# ATTACHMENT 2 - RESUBMITTAL

## COMMENT RESPONSE LETTER

NEW RIVERSIDE - STORE # 1062  
SC HIGHWAY 46 & E PARKSIDE COMMONS  
BLUFFTON, SOUTH CAROLINA

7 CAR WASH ELEVATION - LEFT  
1/4" = 1'-0"

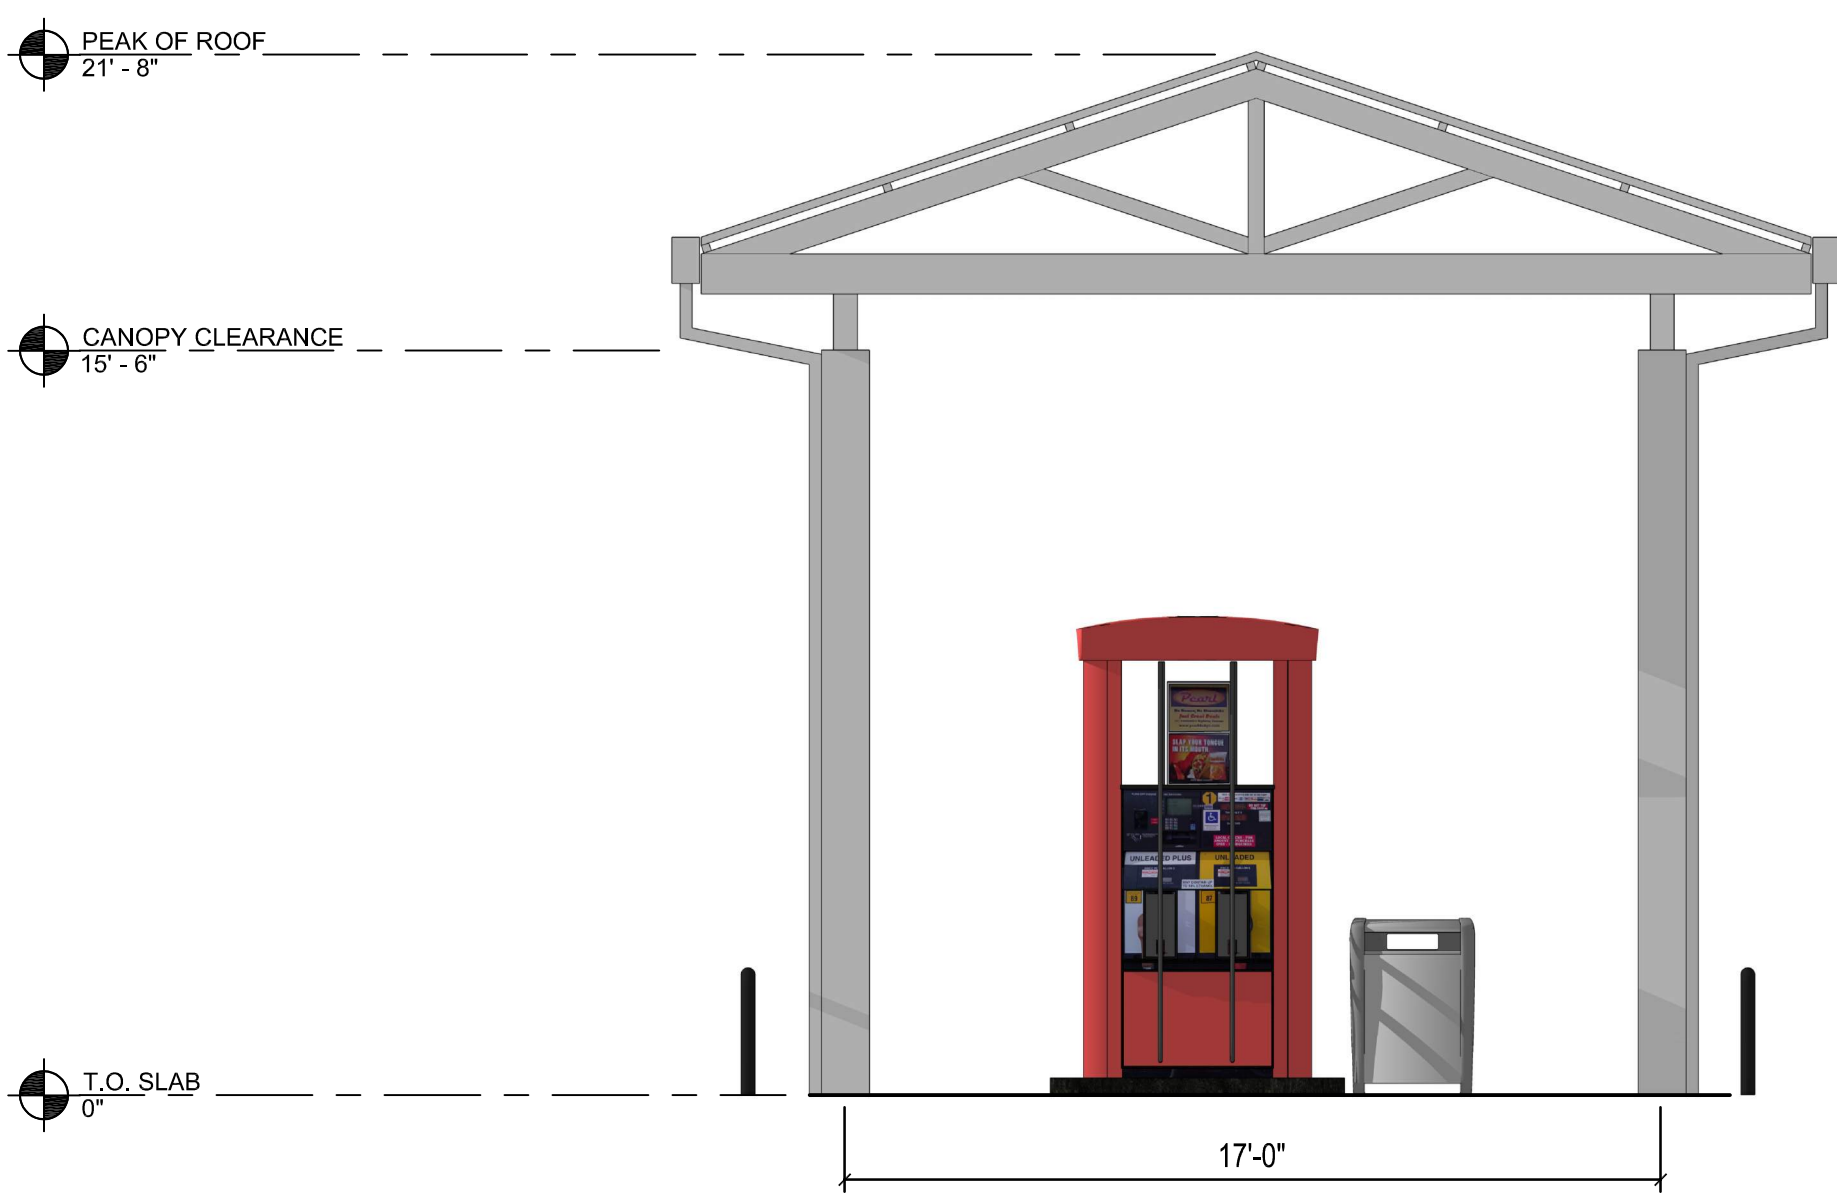
- b. Per Section 5.15.9.(D)(2), the 2 and 12 pitched roof must be revised to a minimum of 4 and 12.

Response: Car wash roof has been modified to comply with 4:12 minimum.

8 FUELING CANOPY ELEVATION - SHORT  
1/4" = 1'-0"

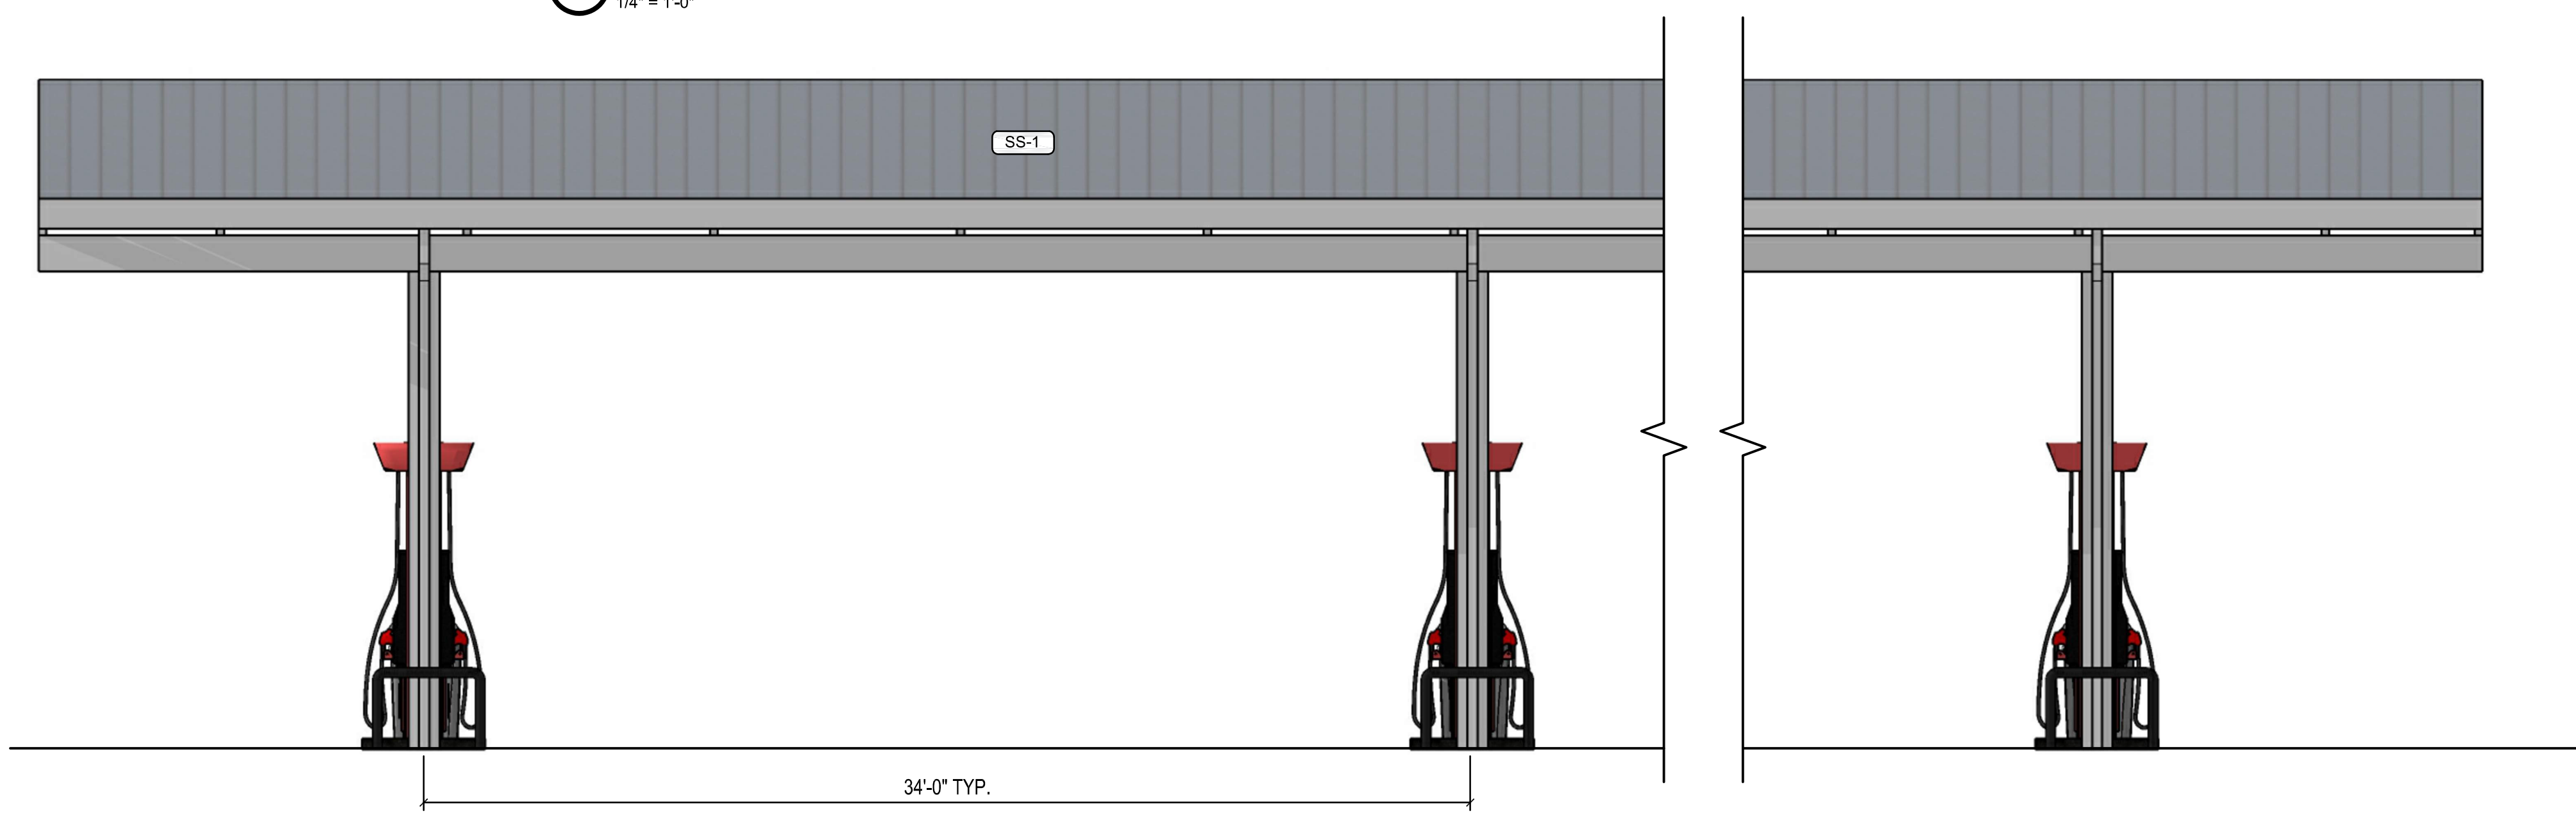
- c. Per Section 5.15.9.(D)(2), a determination on the appropriateness of the curved gas canopies must be made, as they are not a typical roof type to the Lowcountry. The sloped roof is not very Lowcountry Vernacular -provide alternate roof – ensure 4:12 pitch

Response: Canopy has been changed to be a full gable canopy.

PRELIMINARY  
LANDSCAPING PLAN

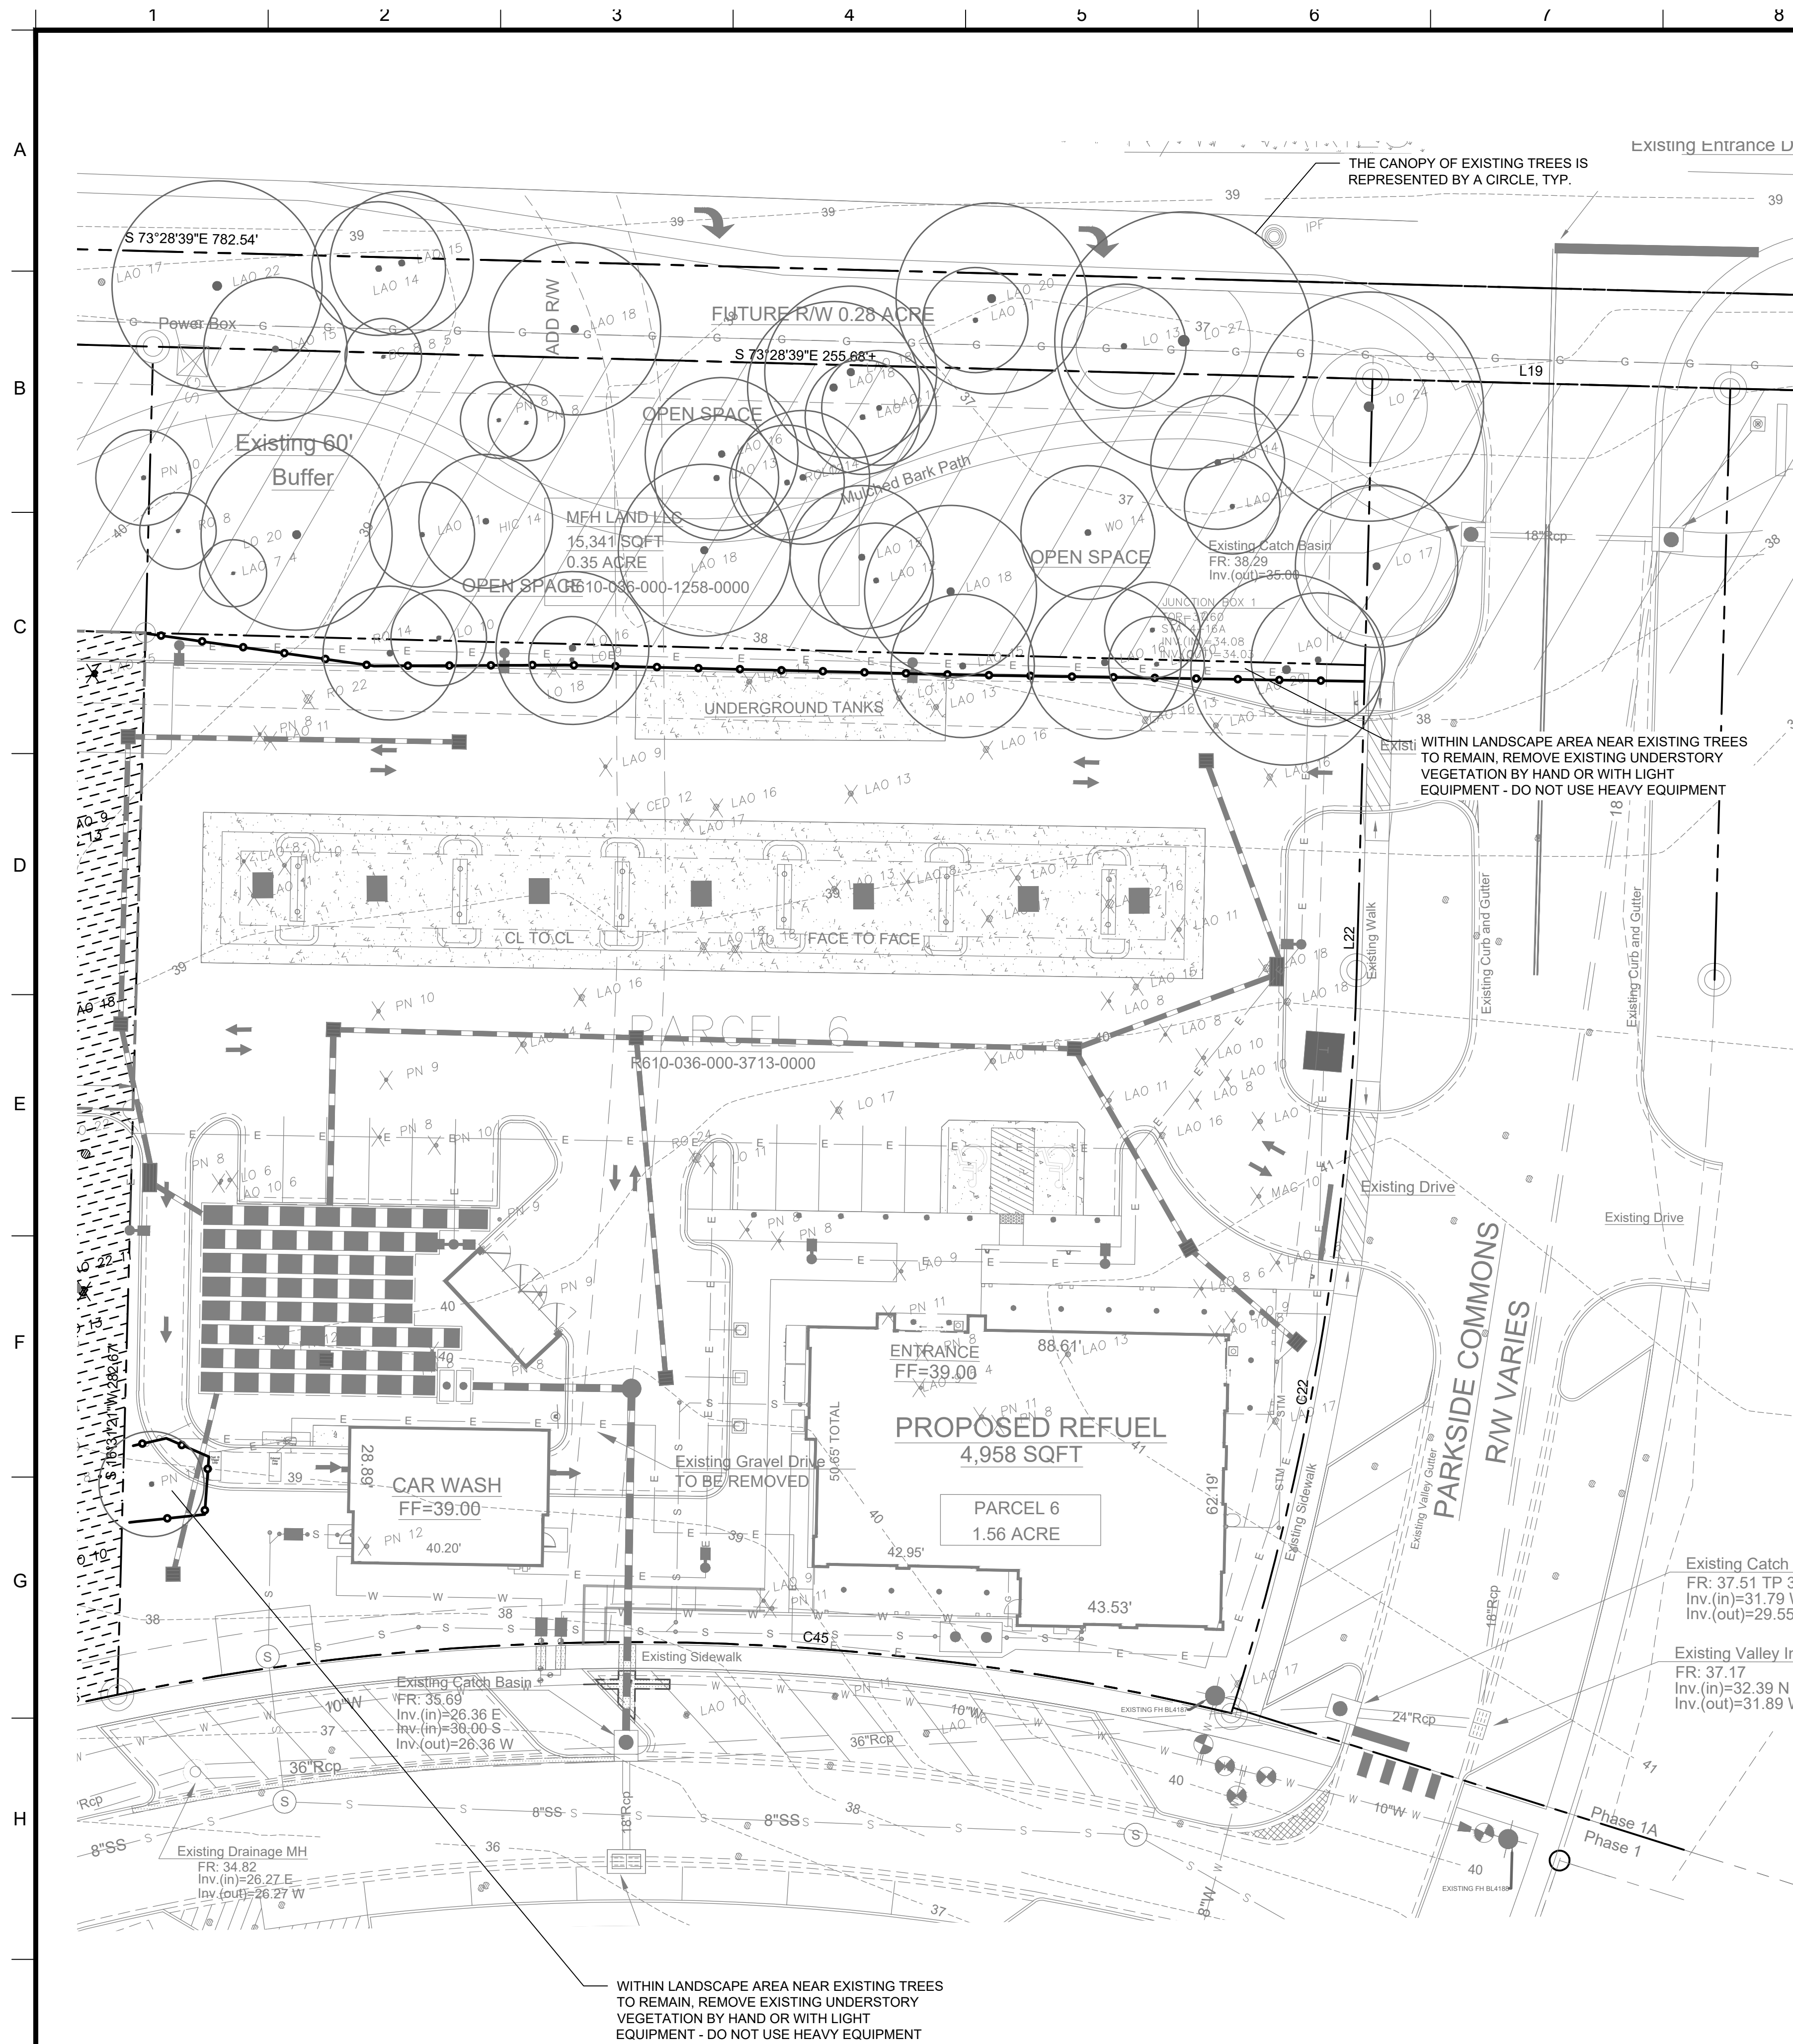
**Comment 1**      *Per Section 5.15.8.D.(2) of the BZDSO, the Landscape Plan must be updated to include additional plantings to create an eight (8) foundation buffer along the east side. Take a look at the parking requirements as losing some of this or relocating it may provide the ability to have the require buffering and allow space for the ice/coolers.*

**Comment 2**      *Per Section 5.15.8.D.(5) of the BZDSO, the 1 ½" caliper dbh Washington Hawthorns used as Landscaped Peninsula trees must be increased to a minimum of 2" calipers.*

**Comment 3**      *Revisit the landscaping to add additional evergreen species as many of the ones on site are not.*

**Comment 4**      *Revisit the species in the foundation plantings to add some height (remain low under windows though)*

Response 1: Comment Acknowledged. The landscaped buffer along the west side of the building has been widened to provide a minimum 8-foot wide planting area around the entire building.

Response 2: Comment Acknowledged. The caliper of the hawthorns has been revised as requested.

Response 3: Comment Acknowledged. Evergreen species have been added to the landscape plans.

Response 4: Comment Acknowledged. Species of the foundation plantings have been revised to add some height.
